# Access Compliance Report

### (Curb Ramps)

Intersection ID: 29978	Main Street: ALBANS_LN	Cross Street: BARVAS_ST	Location: NW
ADA ID: BD0474C37294	Ramp Type: PerpDiag	Initial Pass/Fail: Fail	Overall Compliance: No
Severity Score: 10			
Codes/Mitigation Info/Possible Solution		Field Measurements/Component Compliance

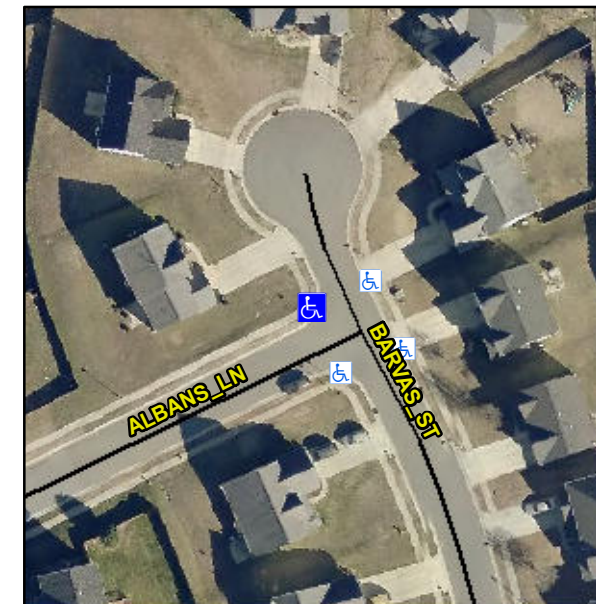
**Not Found, R304.5.1, R304.5.3**

Compliance	Description	Data	Compliance	Description	Data
N/A	Ramp Length (in)	48.0	Yes	Ramp Slope (%)	6.4
No	Ramp Width (in)	36.0	No	Ramp XSlope (%)	4.9
N/A	Flare Type LT	N/A	N/A	Flare Type RT	N/A
N/A	Flare Slope LT (%)	N/A	N/A	Flare Slope RT (%)	N/A
N/A	Flare Traversable LT?	N/A	N/A	Flare Traversable RT?	N/A
N/A	Landing Length (in)	N/A	N/A	DWS Provided?	N/A
N/A	Landing Width (in)	N/A	N/A	DWS Contrast?	N/A
N/A	Landing Slope (%)	N/A	N/A	DWS Length (in)	N/A
N/A	Landing X Slope (%)	N/A	N/A	DWS Full Width?	N/A
N/A	Landing Curb? (Y/N)	N/A	N/A	DWS Offset (in)	N/A
N/A	Shared Landing?	N/A			
N/A	Gutter Ponding?	N/A	N/A	Gutter Slope (%)	N/A
N/A	Gutter Lip Ht (in)	N/A	N/A	Gutter X Slope (%)	N/A
N/A	Painted X Walk1?	No	N/A	Painted X Walk2?	No
	X Walk 1 Direction	To S		X Walk 2 Direction	To E
N/A	X Walk 1 Width (in)	N/A	N/A	X Walk 2 Width (in)	N/A
	X Walk 1 Slope (%)	1.1		X Walk 2 Slope (%)	1.4
	X Walk 1 X Slope (%)	3.7		X Walk 2 X Slope (%)	5.0

**Remove & Replace Curb Ramp With Two New Directional Ramps or Equivalent.**
